**United Kingdom Holocaust Memorial  
and Learning Centre**

Design and Access Statement Addendum  
April 2019

The revised proposal retains the original Masterplan and incorporates the following amendments:

- Revised design for the Entrance Pavilion;
- Adjustments to the design of the memorial courtyard and associated landscaping;
- Rationalization of the Learning Centre footprint
- Extension of the Learning Centre Mezzanine level;
- Repositioning of the skylight within the landscape

Site Plan

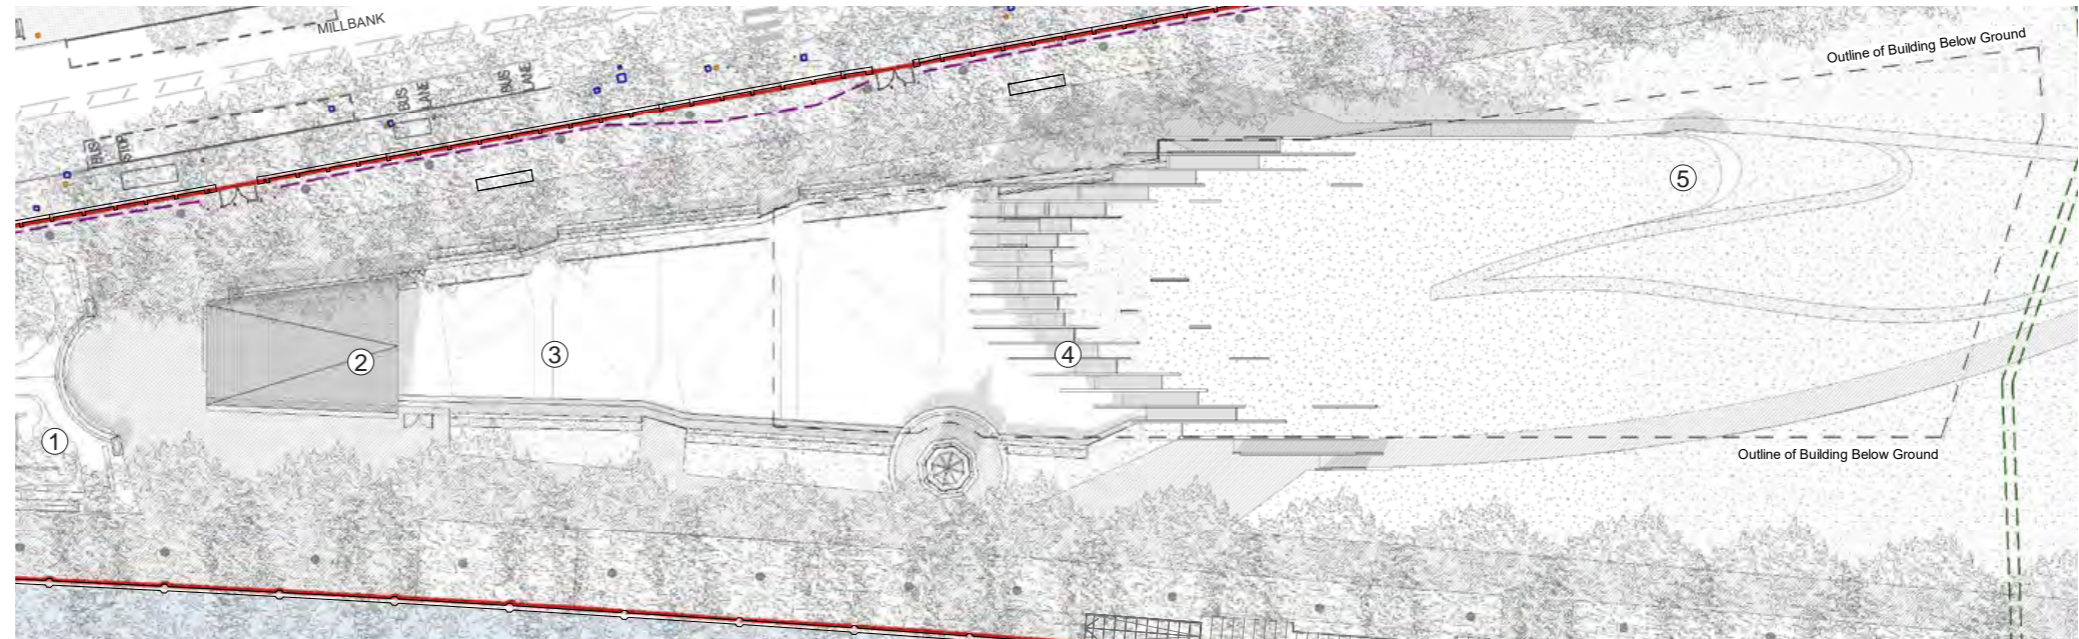
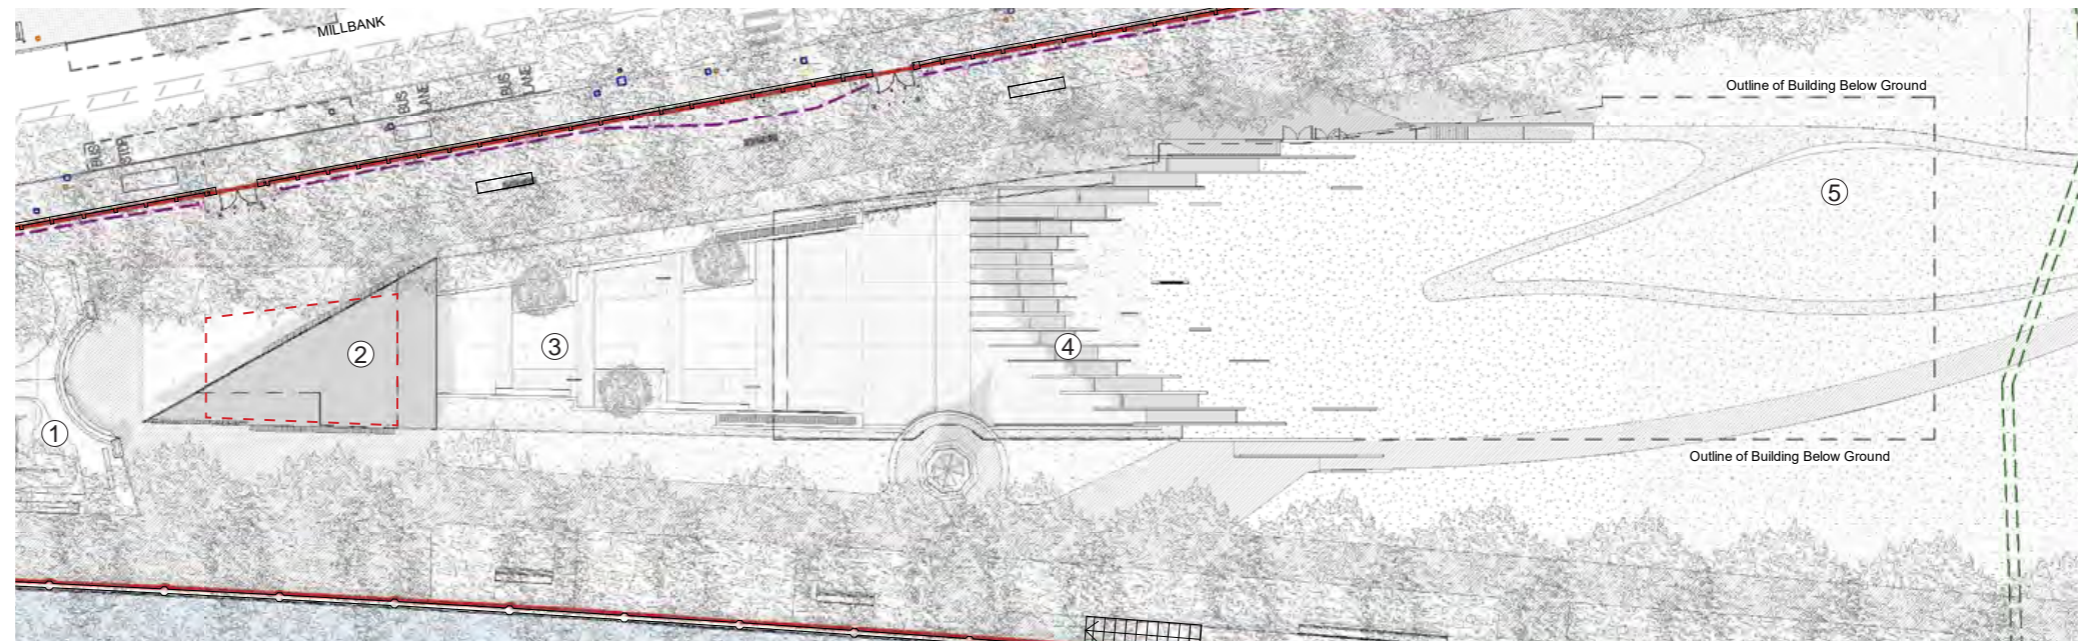
The amended proposal includes a triangular shaped pavilion that creates a greater sense of space and openness from Park Entrance 4 allowing a visual connection to the Spicer Memorial

Plan

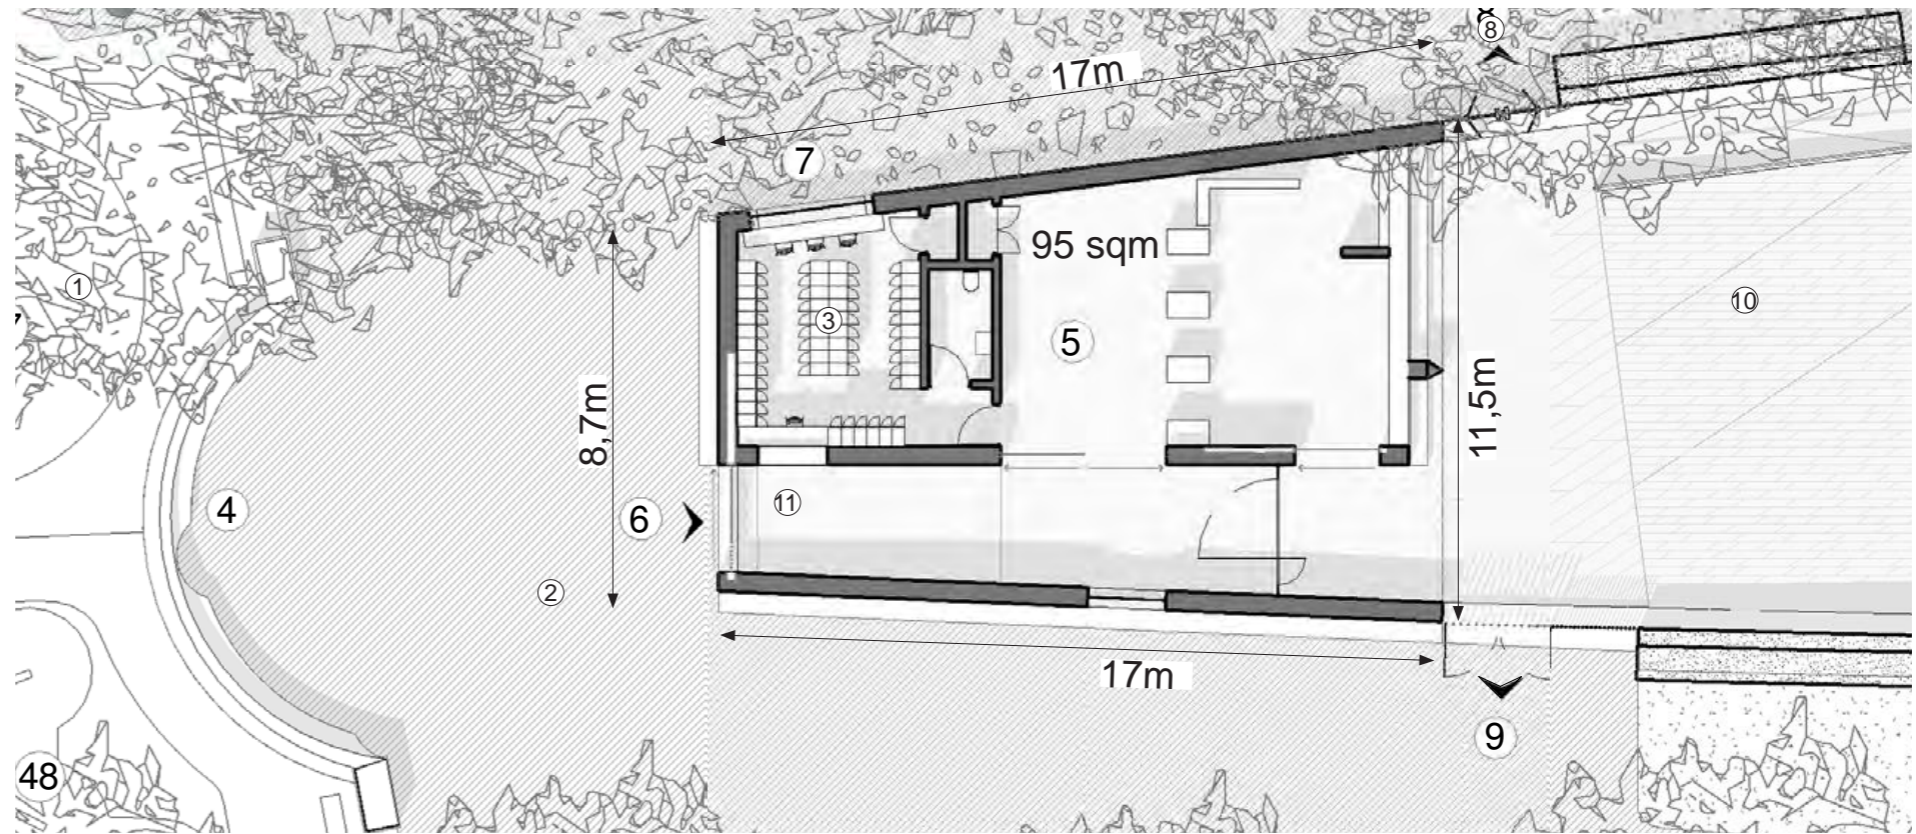
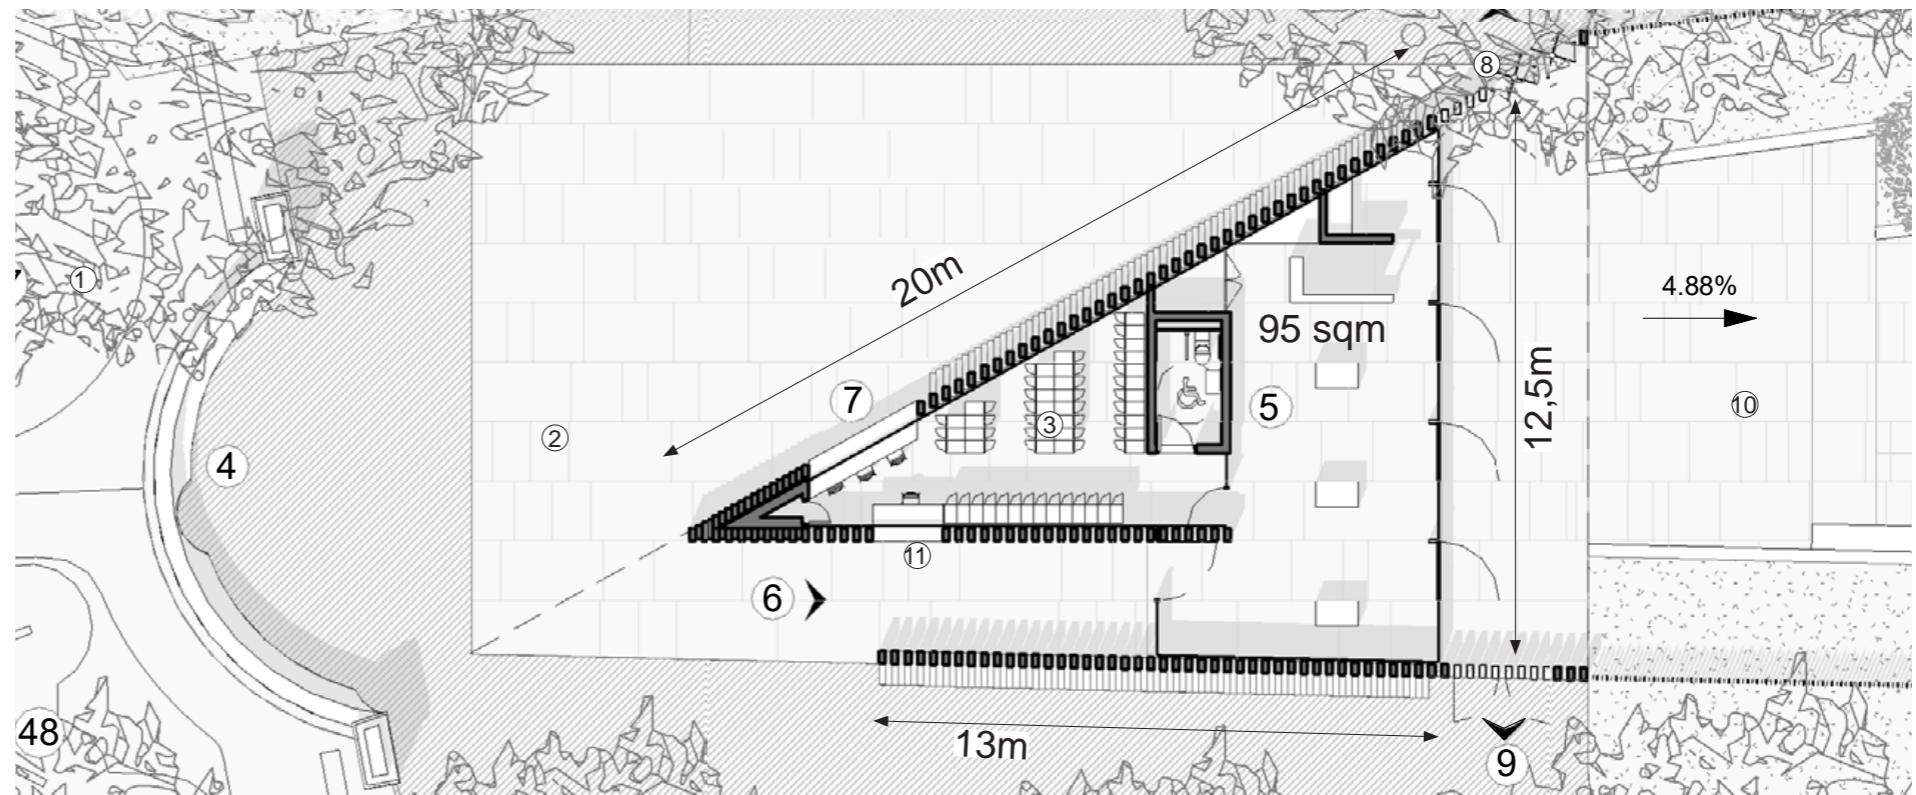
As per the December 2018 Application the small pavilion incorporates a covered entrance at the east side, where tickets will be checked. This space connects directly to the security area where small bags will be checked. The locker area includes two windows, one facing the covered entrance for a bag drop off desk and a second window facing Millbank providing information and bag collection points..

The proposal identifies a dedicated gathering area on the east and west side of the Entrance Pavilion where a long bench invites NHM visitors to sit or gather without disturbing the normal gardens users' movements.

The Pavilion walls are composed of vertical columns that are spaced to allow visual connection through the Pavilion and blurring the lines between outside and inside.

Courtyard Edge

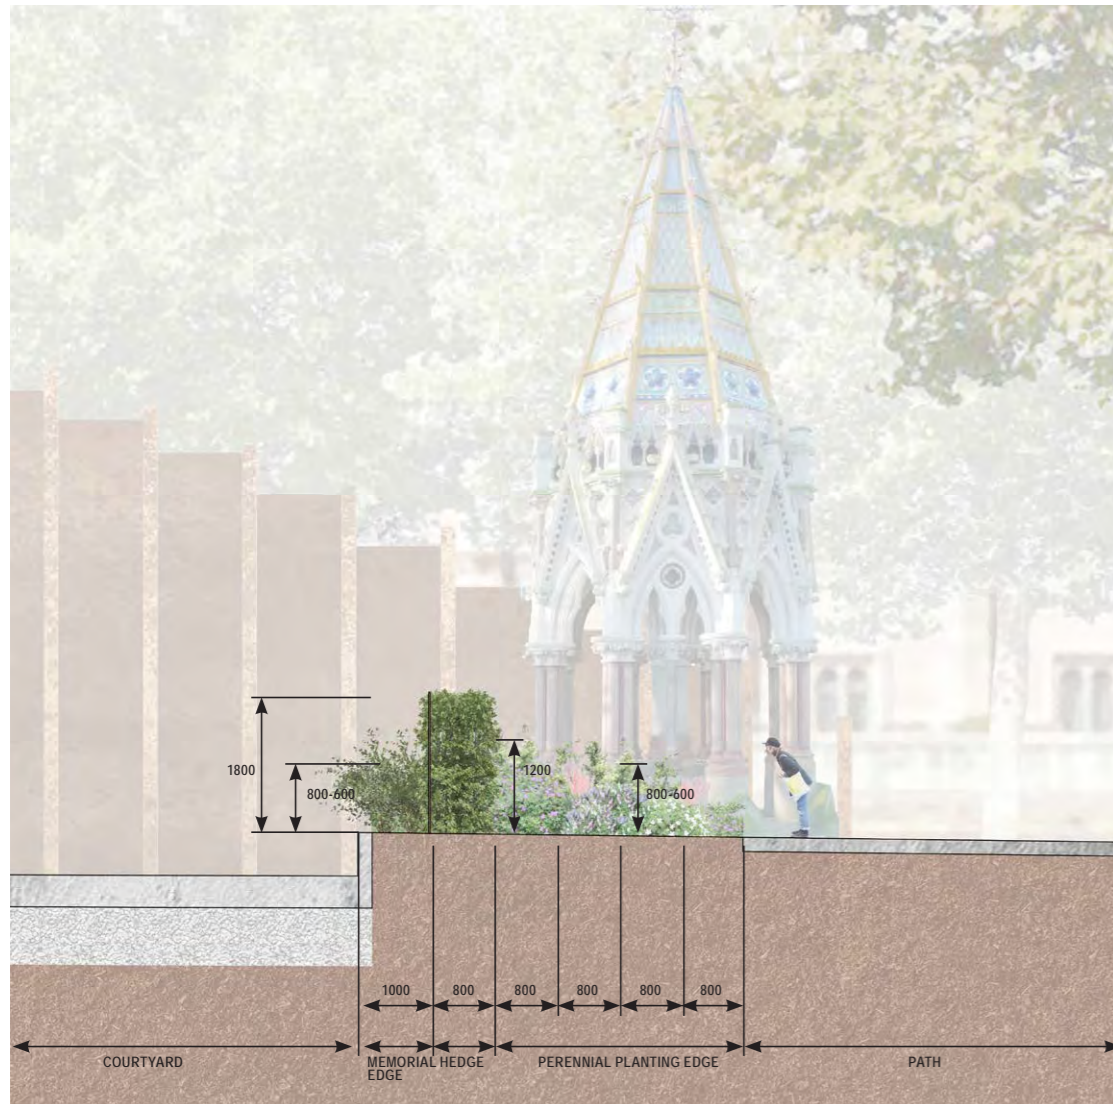
The perimeter fence was reviewed, particularly the areas around the Buxton Memorial. In these areas the boundary fence was simplified: the 1800mm tall glazed panels were removed and replaced by a 1100mm tall fence that allows a clearer view of the Buxton from Millbank particularly the axis view from Dean Stanley Street towards the gardens.

## Site Plan

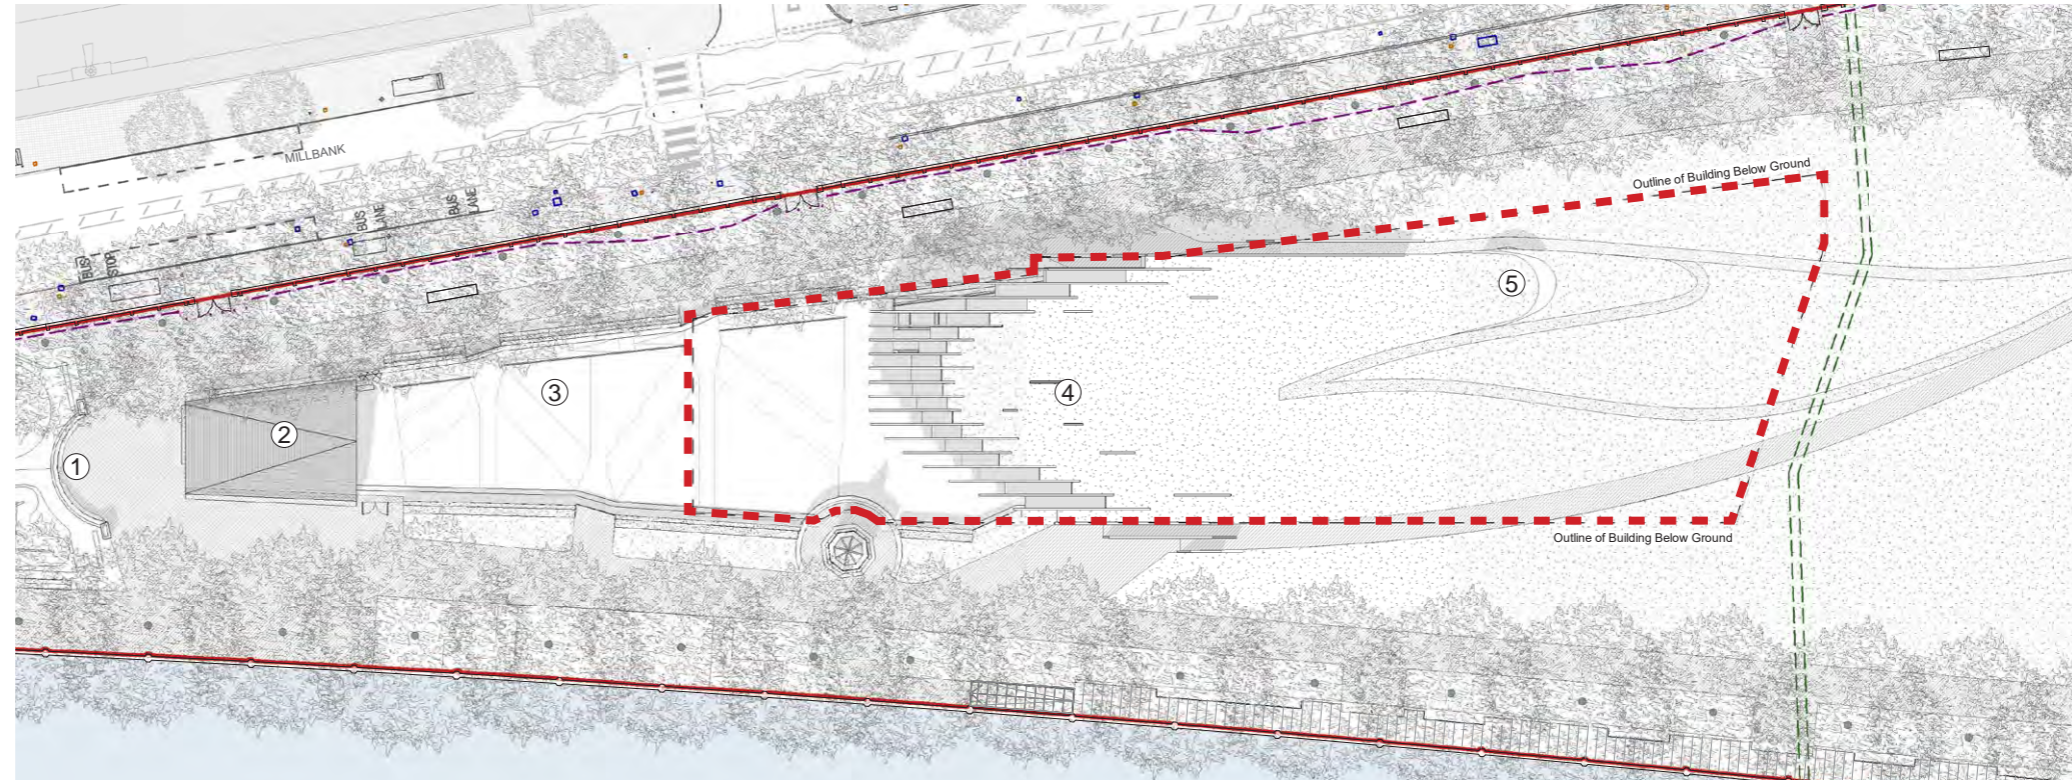
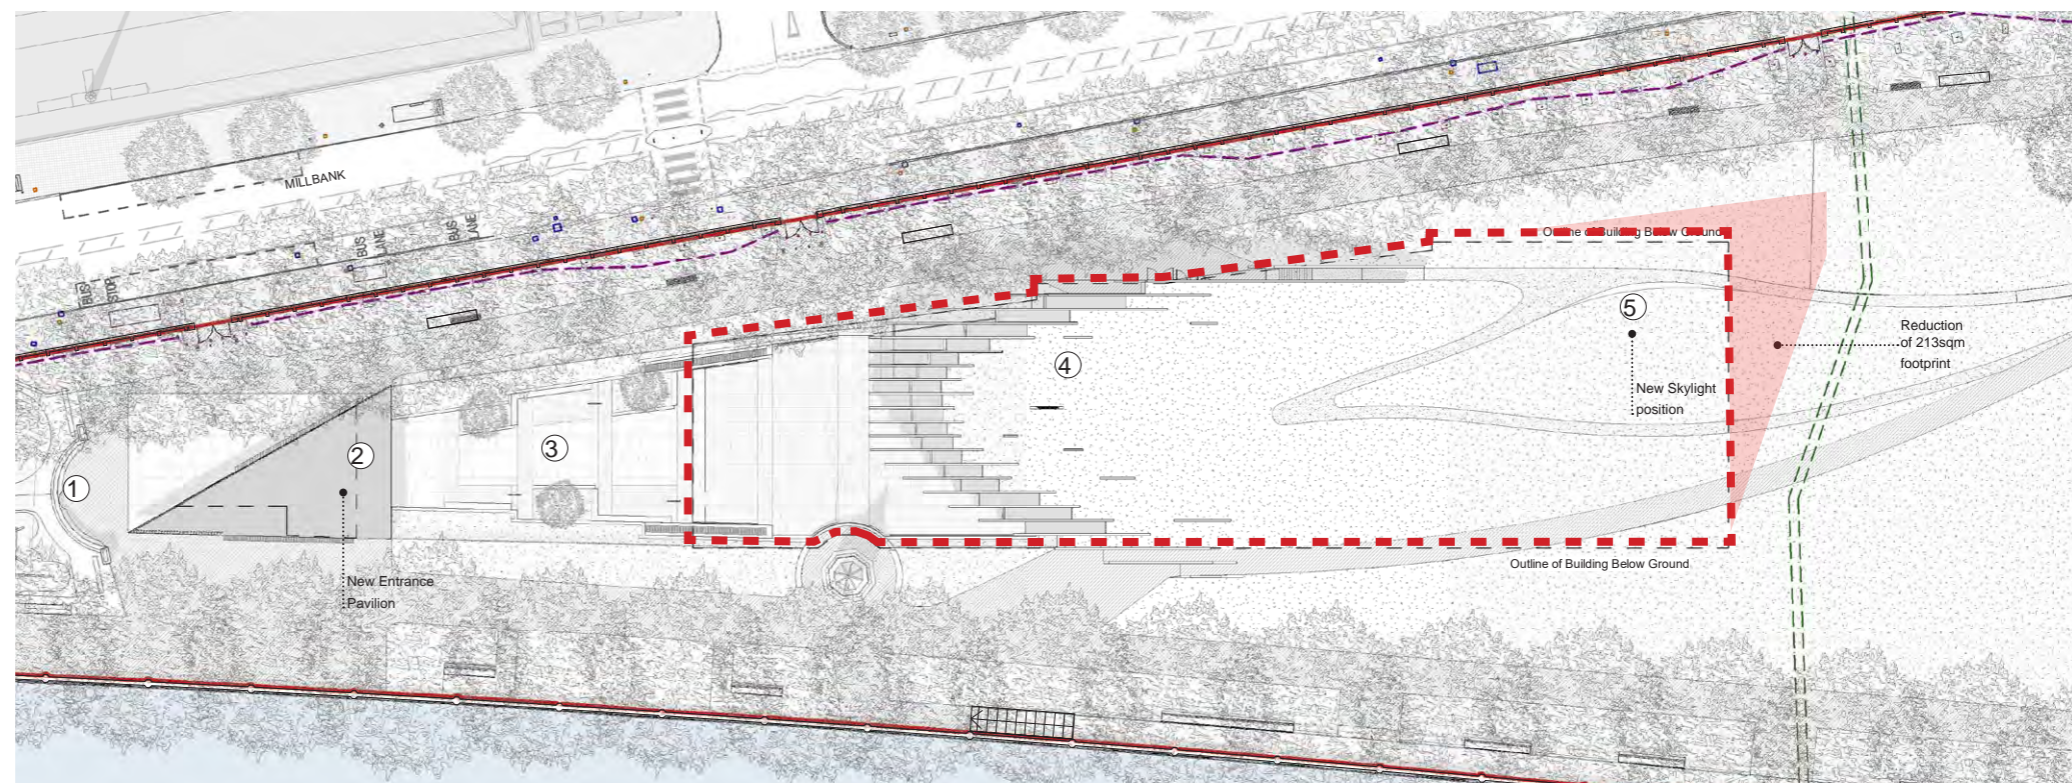
The Learning Centre footprint was rationalised at the western and northern end, reducing the basement plan by 213sqm, whilst the skylight was relocated further north.
